SERVICE BULLETIN
SUMMARY

**TITLE: AIR CONDITIONING - AIR COOLING SYSTEM - REMOVE AIR
CONDITIONING PACK P/N 2401A0000-01 AND INSTALL THE
PREVIOUS ONE**

A318/A319/A320/A321

MODIFICATION No.: 151098K14007

Figure A-GSAAA - Sheet 01

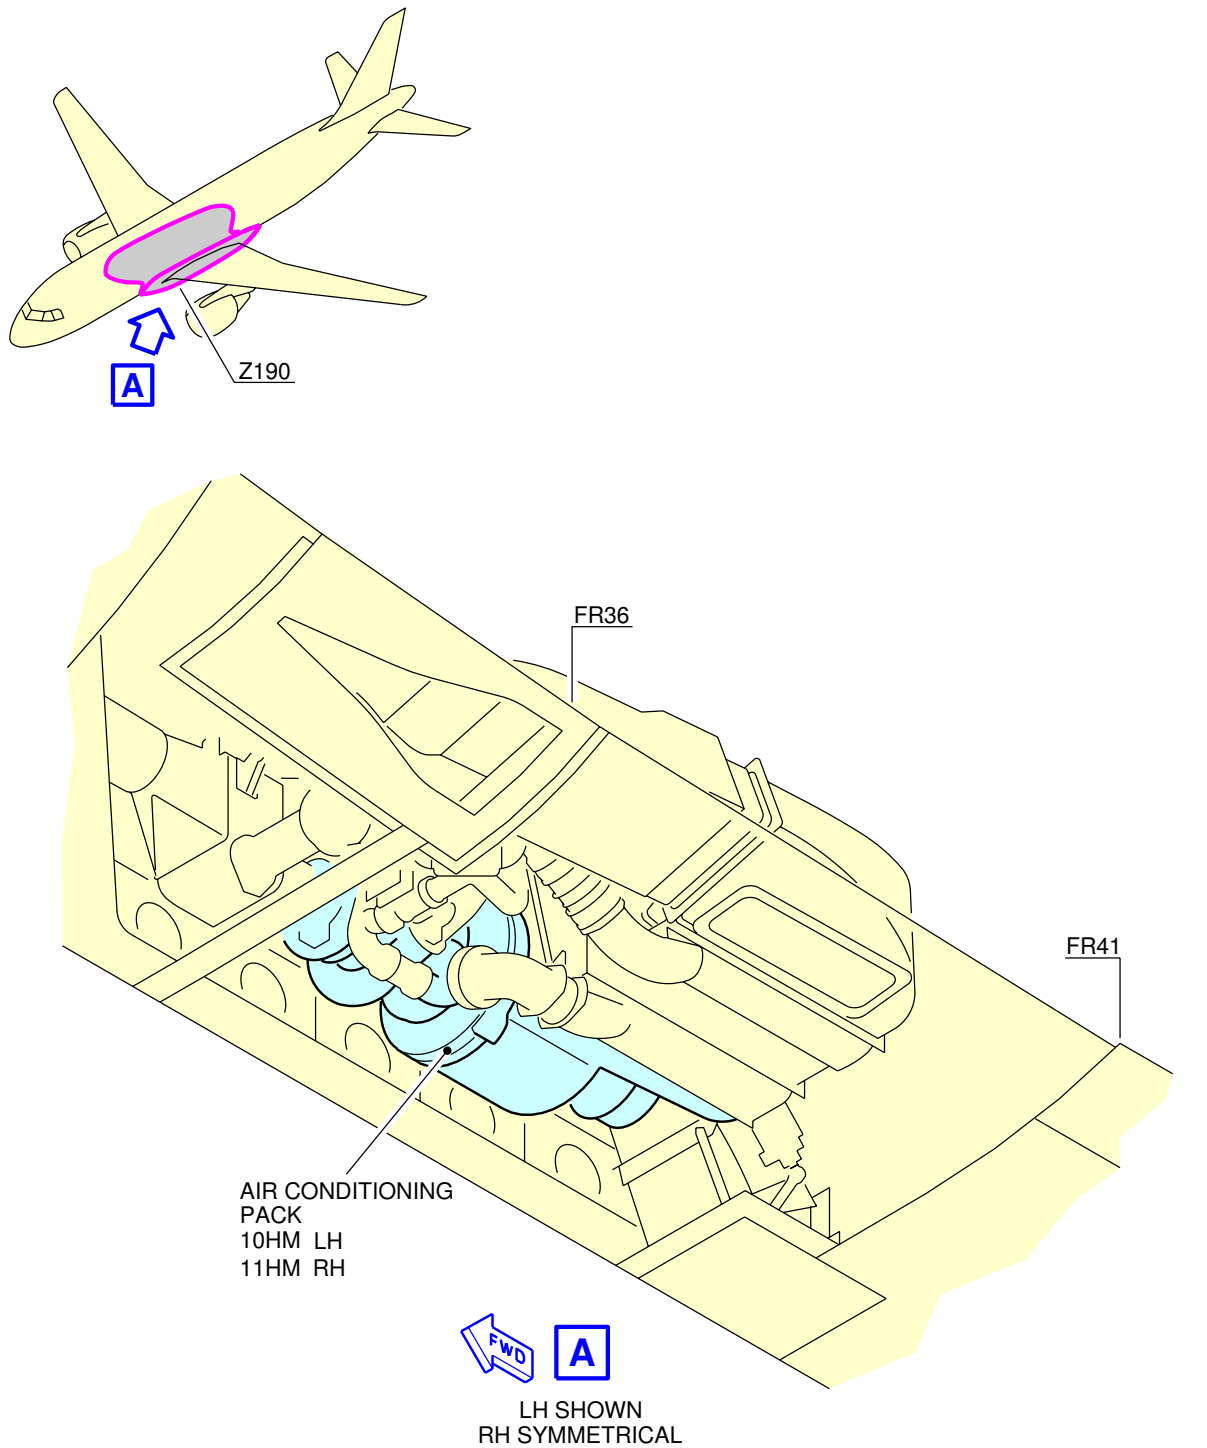
Air Conditioning Pack (10HM and 11HM), PN 2401A0000-01, has been evaluated in-service on selected aircraft. The results of the evaluation show that contamination has caused significant abrasion of the bearings in the Air Conditioning Packs.

In conclusion, it is recommended to revert the Air Conditioning Packs (10HM and 11HM), PN 2401A0000-01, to the previous standard Air Conditioning Packs, PN 2301A0000-01.

- Remove the existing Air Conditioning Packs (10HM and 11HM), PN 2401A0000-01
- Modify the Air Conditioning Packs (10HM and 11HM) in accordance with LIEBHERR-AEROSPACE Service Bulletin No. 2401A-21-02
- Install the Air Conditioning Packs (10HM and 11HM), PN 2301A0000-01.

Figure A-GBAAA - Sheet 01
Removal and Installation of Air Conditioning Packs

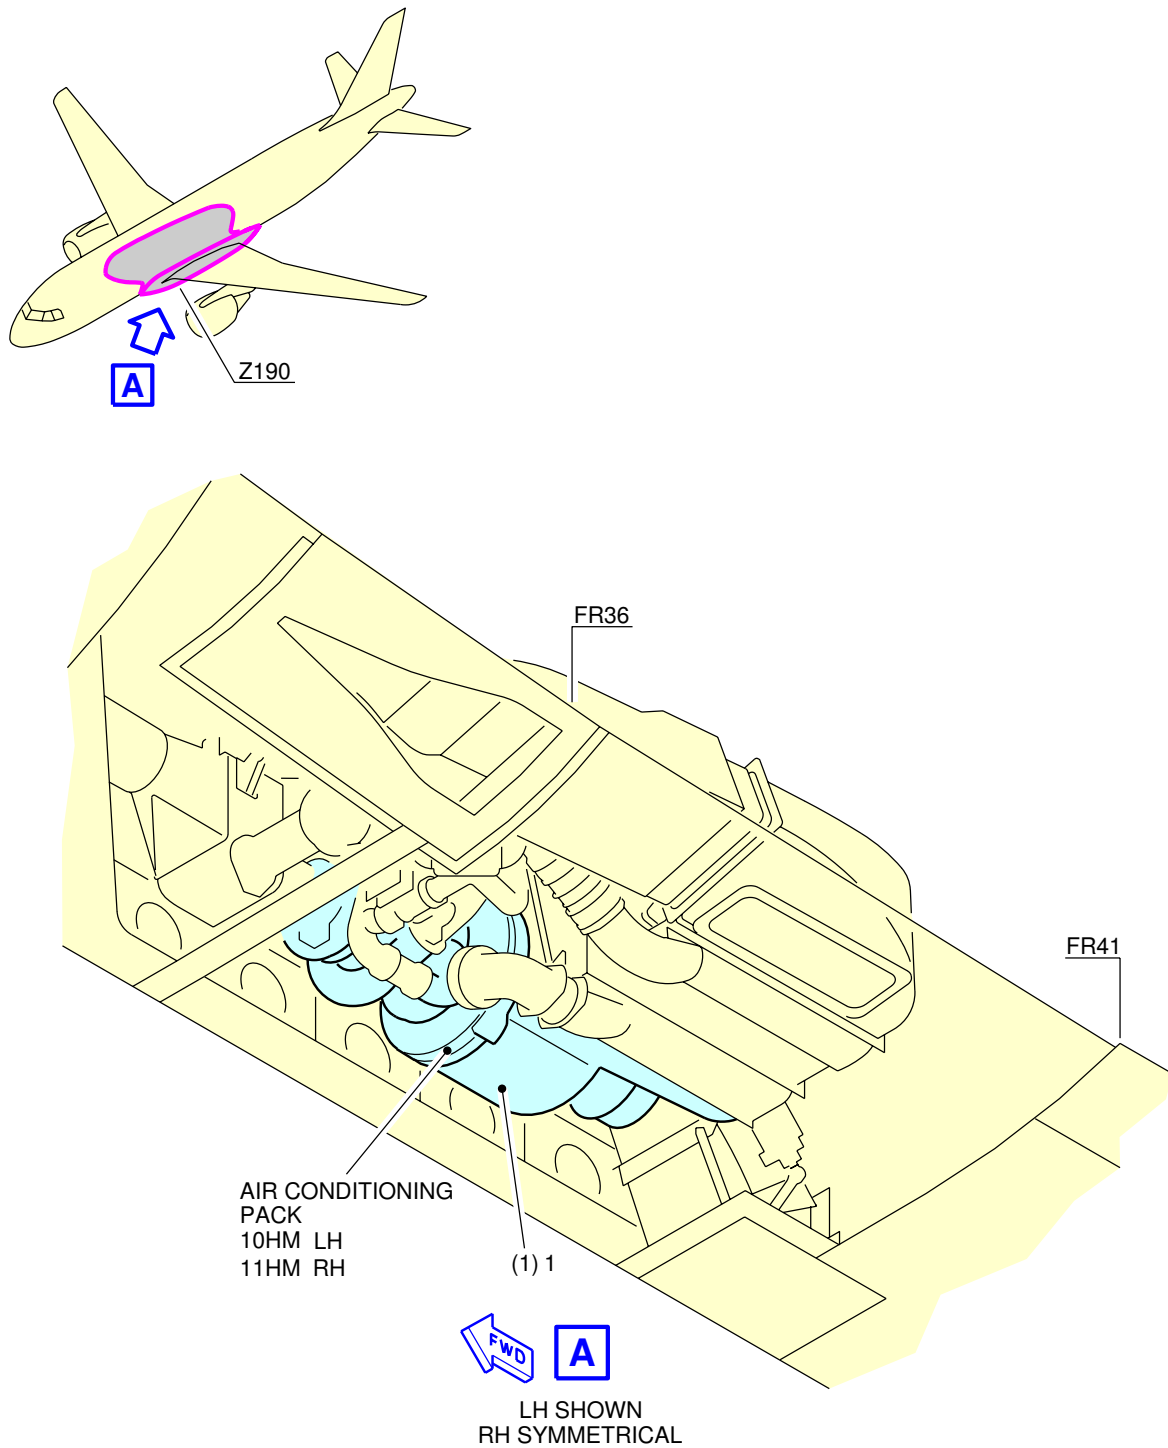
- (a) Remove the Air Conditioning Packs (10HM and 11HM) (Refer to AMM Task 21-52-41-000-001 and [Fig. A-GBAAA](#)).

- (a) Install the Air Conditioning Packs (10HM and 11HM) (Refer to AMM Task 21-52-41-400-001 and [Fig. A-GBAAA](#)).

- (a) Remove the Air Conditioning Packs (10HM and 11HM) (Refer to AMM Task 21-52-41-000-001 and [Fig. A-GBAAA](#)).

- (a) Install the Air Conditioning Packs (10HM and 11HM) (Refer to AMM Task 21-52-41-400-001 and [Fig. A-GBAAA](#)).

2 Pack-Air Conditioning 2401A0000-01 Item (1) Retain

2 Pack-Air Conditioning 2301A0000-01 Item 1
